**PETITION FOR DECLARATORY STATEMENT  
BEFORE THE FLORIDA DEPARTMENT OF FINANCIAL SERVICES**

Case No.: 104163-09-FM

Waldrop Center Office Building – 28100 Bonita Grande Dr. Bonita Springs, FL 34135

Exhibit A 1-1

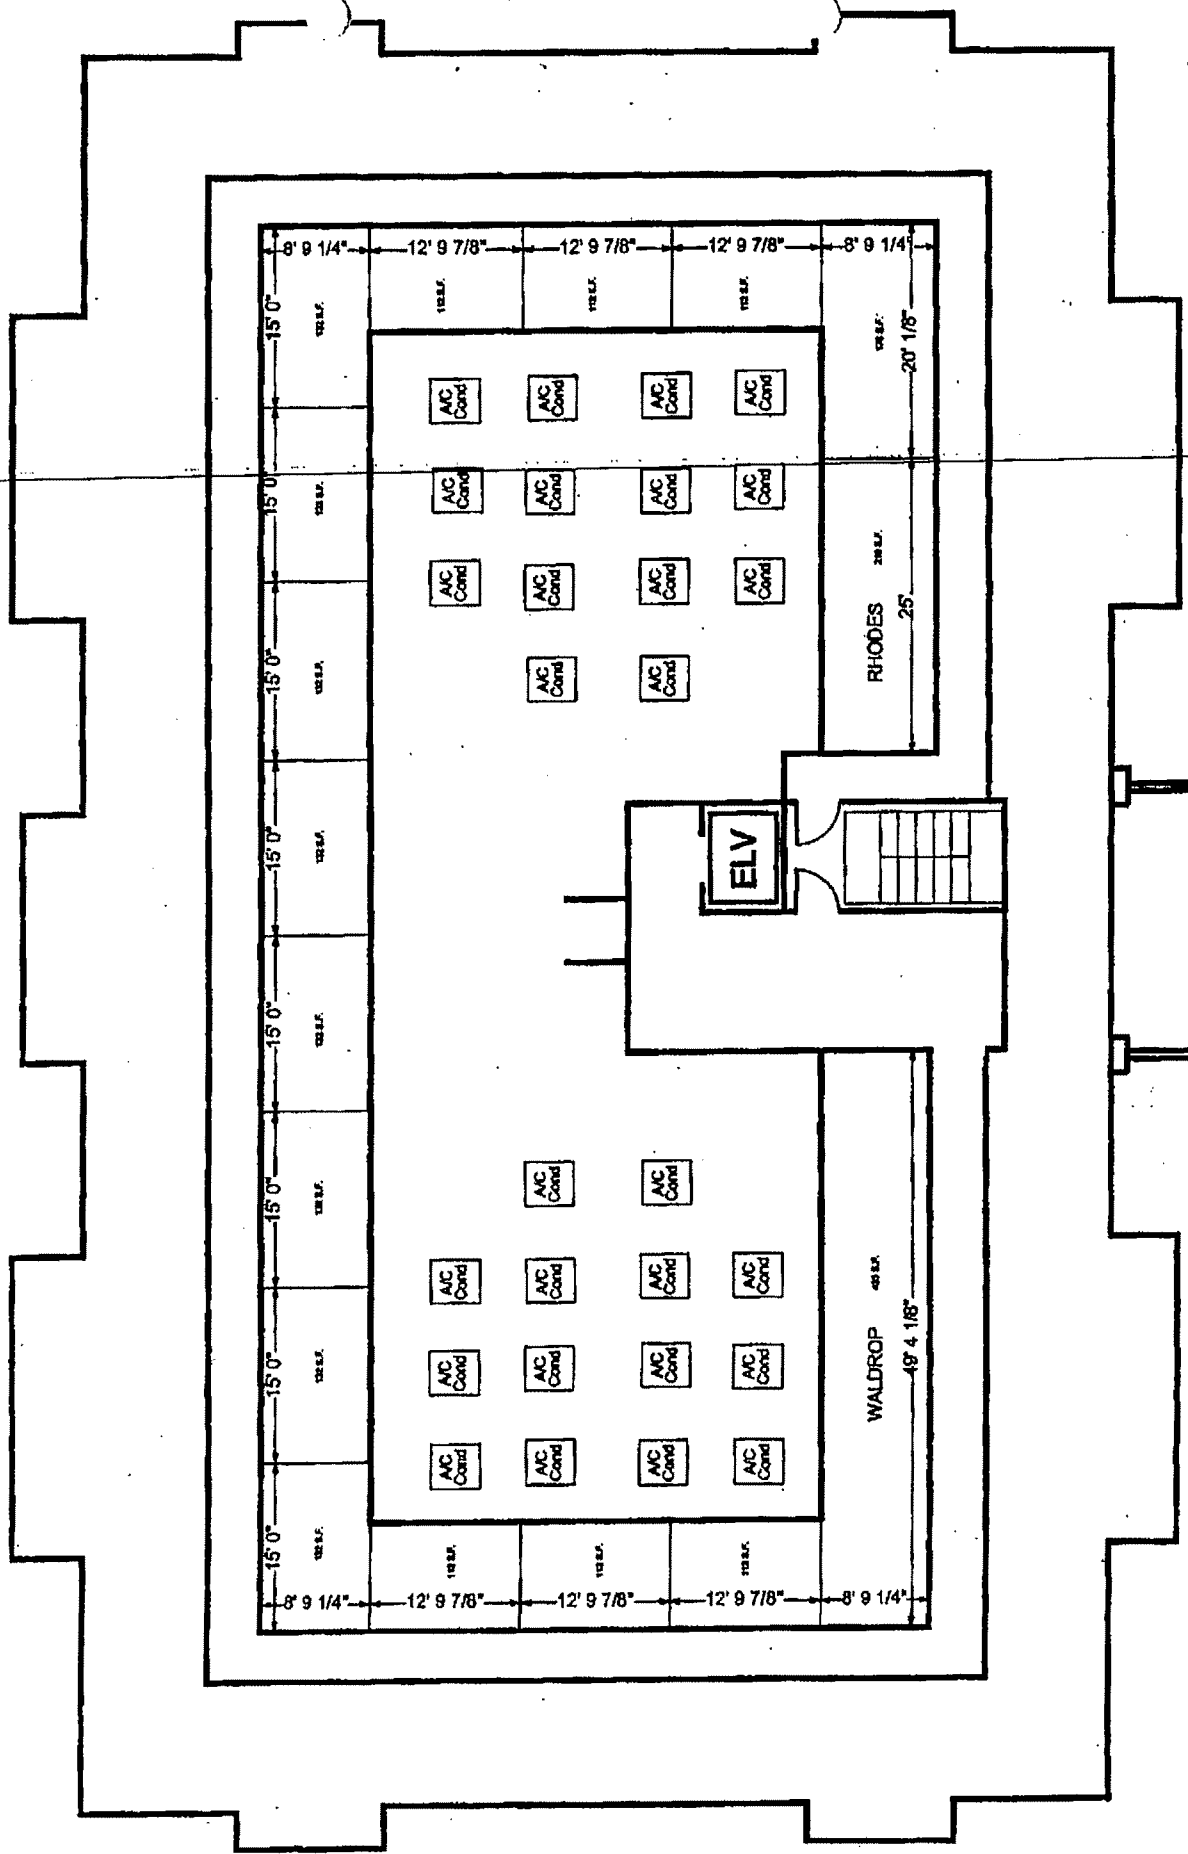
1. Can the local authority having jurisdiction waive code safety requirements that are specifically provided by Code? FFPC NFPA 101 4.6.1 thru 4.6.1.3
2. From a review of Exhibit A, does the single stair (means of egress) with two exit doors comply with code section FFPC NFPA 101 38.2.4.1?

2. From a review of Exhibit A, does the single stair (means of egress) with two exit doors comply with code section FFPC NFPA 101 38.2.4.1?

The attic area is only accessible to one means of egress (stair), and not two separate means of egress as required by Code. The two doors on the existing stair does not count as two separate means of egress as defined by FFPC NFPA 101 3.3.151, but would be two separate exit doors into one means of egress that discharges out of the building.

The Code requires two Means of Egress that are continuous and discharges to the public way. Therefore, in order to convert the attic space into another floor that would be used for incidental storage to the Business Occupancy, another separate Means of Egress needs to be provided. Also, please keep in mind that there other applicable Fire or Building Codes that would apply here if the attic space is converted into another floor.

The attic space of your building cannot be used for incidental storage to business occupancy (your building) because there are not two separate means of egress (stairs) provided on that level. If you decide to add another separate means of egress (stair), then I will discuss the other applicable Fire Codes that will apply. Please keep in mind that the Building Code has applicable codes that would also apply, and can only be enforced by the Building Official.
